NAVSHIPS 0967-000-0050

**ELECTRONICS
INSTALLATION
AND
MAINTENANCE BOOK**

RADIAC

CHANGE 4 TO
NAVSHIPS 0967-000-0050
(Formerly NAVSHIPS 900,000.5)

Figure 1.

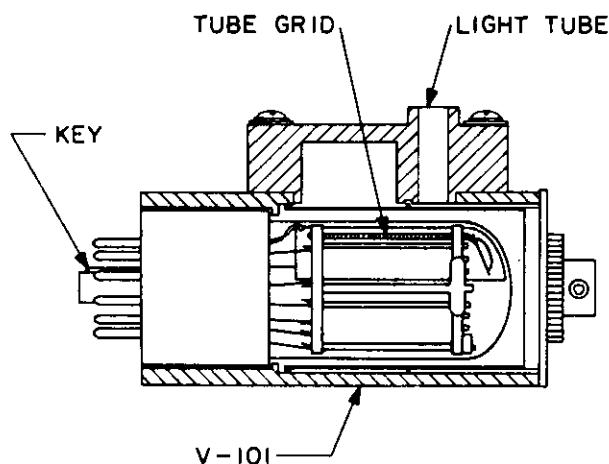
AN/PDR-18B-JIG FOR CHECKING PHOTOMULTIPLIER TUBE (1P21)

RADIAC Set AN/PDR-18B is a scintillation-type instrument that has a "calibrate" position. In this position the calibration aperture admits light from the luminous standard E-102 and through the light tube to the grid of the photomultiplier tube. In some instances, due to the varying lengths of the grid of the vacuum tube, the light from the luminous standard does not fall entirely on the grid, but is partially blocked by the ceramic insulator in the vacuum tube. This makes it difficult to calibrate the instrument properly.

The jig is made by utilizing part A-106, tube shield with shutter 0-110, and part E-103, sawed in half so that the tube can be observed in relation to the light tube. The sketch in figure 1 of this article shows a tube (1P21) placed in the jig and the relationship of the grid with respect to the light tube. This method takes approximately 3 seconds as compared to the old method which took approximately 15 minutes.

Figure 1. Swipe A: Handle; fabricate from 0.020-inch-thick Melamine; stock number HM 5970-468-5530; unit of issue, square yard. B: One-inch filter disc cut from Whatman No. 50 filter paper or equivalent. C: Cement; General Electric RTV-102 Silcone rubber adhesive sealant or equivalent.

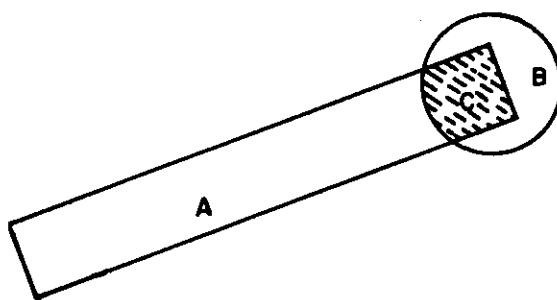
With a swipe (consisting of a thin plastic handle with one-inch filter disc attached, see figure 1) damped with a couple of drops of decontaminant reach into the area between the gear plate and the calibration source E-202 and wipe the plastic top of the source three times. Dry the wipe sample and determine the activity on the wipe using the CP-295/UD, RIDL 49-54 or equivalent. If the activity of the wipe is 0.005 Microcuries or greater, the gear plate, gears, springs and adjacent surfaces should be wiped to determine the spread of contamination. The defective source shall be removed from the set, placed in a plastic bag and labeled in accordance with MIL-M-19590. The plastic bag should then be sealed and stowed, preferably in a leadlined

Note: A very thin coat of cement is applied to the end of the handle. Place the one-inch disc onto the handle and press hard so that all excess cement is pressed from between the handle and the disc. If an excessive amount of cement is left between the handle and the disc, the swipe will be too thick to enter the area between the gear plate and the source. Allow several days for the thin coating of cement between the handle and the swipe to dry or set up.

Figure 1. Meter Linkage Assembly

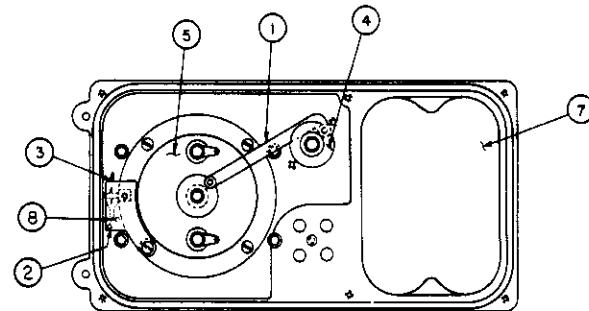
AN/PDR-27J—REPAIR TO INDICATING METER M-101 IN RADIAC SET

Indicating meter, circuit symbol number M-101, of the type used in the manufacture of the AN/PDR-27J's is not available from supply. If a meter of this type fails, it can be repaired with:

1. Indicating Meter, type MR36M201SPECR, Federal Stock Number 1N6665-069-3031.
2. Kit Meter Linage Assembly, Federal Stock Number 1N6665-789-1837, consisting of two separate subassemblies as follows:
 - a. **Meter Linkage (Bar Type)** - link bar, 2 cranks, together with rivets and set-screws (see figure 1).
 - b. **Lamp Holder Assembly** - Mounting board, lamp, lamp holder clip, lamp holder screw and nut (see figure 1).
 - c. **Machine screws (3)** RH 4-40 thread, 1/2-inch long, (1) RH 4-40 thread, 5/8-inch long.
 - d. **Lockwashers (4)** Number 4.
 - e. **Flatwasher (1)** Number 4.
 - f. **Solder.**

5. Insert the three 1/2-inch 4-40 screws with No. 4 lockwashers through the three holes in the terminal board mounting bracket that are now used to mount the Lamp Holder Assembly and then into the meter mounting holes and partially tighten (refer to figure 1).
